**Subject:** FW: TAC Meeting February 1 at 200 pm **Date:** Thursday, January 27, 2022 11:53:00 AM

RE: 0 Borthwick Ave Meeting: TAC 04-05-22

RE: 404 Islington St (Martin Hill Inn)

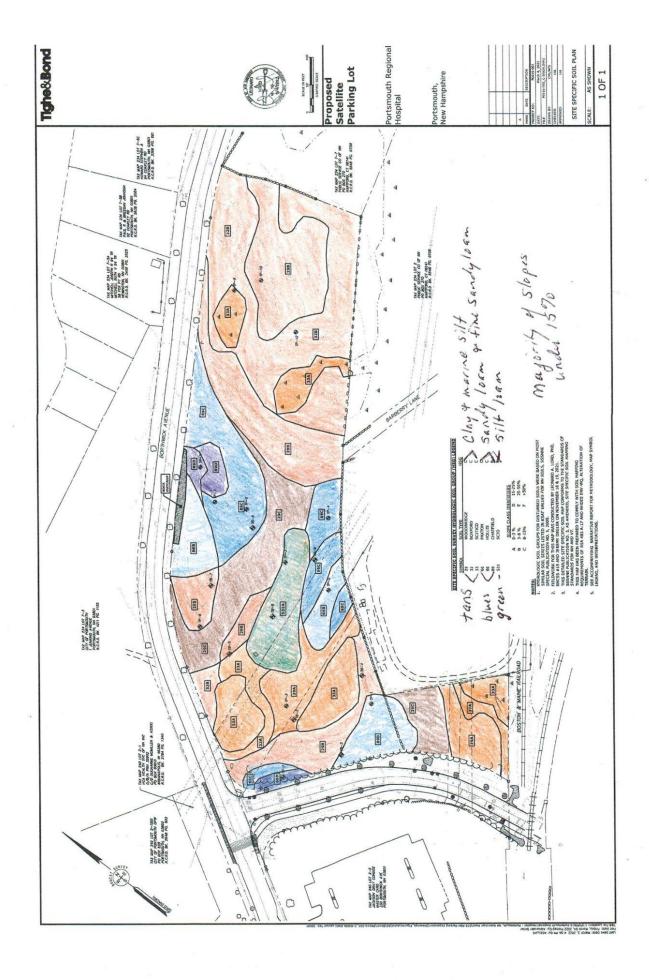
Numbers are always interesting. The most interesting is the lot is stated as being 9.09 acres, 395,745 sf. However, all the drainage reports show 351,712 sf. What happened to the other 44,033 sf of land? It can be appreciated that the proposal seems to respect the 100' wetland buffer on the rear of the property by *not building on it*. However, the amount of unnatural run-off will likely have a negative impact on this highly functional wetland. Section 2 (2-1 drainage analysis) shows existing curve numbers(CN) of 65 and 68 (range 30 to 100) as well as established trees and thick underbrush all parts of a balanced wetland system. *How many other new developments in that area have added or are planning on adding their run off to these valuable wetlands?*

curve number but at the Cation Exchange Capacity (CEC). This tells them how long it will take water to run through their soil, whether it holds water and how often to water. Low CEC soil such as sandy ones need to be watered fast, twice a day, an hour at a time or less. Soils with clay or organic content have a higher CEC and move less than an inch of water an hour. Such land would be watered slowly, for 6 hours or more at a time, every 3 of 4 days. https://www.canr.msu.edu/news/what is your soil cation exchange capacity Looking at the "Site Specific Soil Plan" (colored graphic at end) the majority of the soil on this property is clay and marine silt (tans) It shows silt loam(green) in the middle of the proposed parking lot. The land is relatively flat with most slopes in the 0-8% range and the majority under 15%. Section 3 (3.1 drainage analysis) states the detention system will drain down at longer than 24 hours. However, looking at the majority of soil on this land (clay, marine silt) under existing conditions, drainage based on CECs could take a long time to clear a single rainfall event. The capacity of the underground retention systems is the concern. It does not seem to decrease existing drainage but seems to increase drainage into the wetlands at a far greater rate than currently exist. The "post" curve number average is 79.4 (range 30-100), some of post CN are in the 90s comparing the 2 year pre and post conditions (included at end). Flows greater than the 2 year storm events will bypass the treatment units. Based on normal New England weather it seems a lot of the water will go untreated into the wetland at a much higher rate than existing which was filtered through trees, brushes. grasses and slowly absorbed by clay and marine silt. Does this meet MS4 regulations?

Section 4 (4-3 drainage analysis) states "the post-development flows have been minimized to the greatest **extent practical.**" Walking through the current PRH parking lot on any rainy day one can experience practical vs what is really necessary by wading through LARGE puddles to get to the building. The placement of sidewalks as well as <u>raised</u> planting islands just add to the water issues. The systems should reflect what is "really" necessary and not be allowed to pour untreated water directly into wetlands after typical NE high rain events. It seems expected 2 yr events will overflow unfiltered right off the bat.
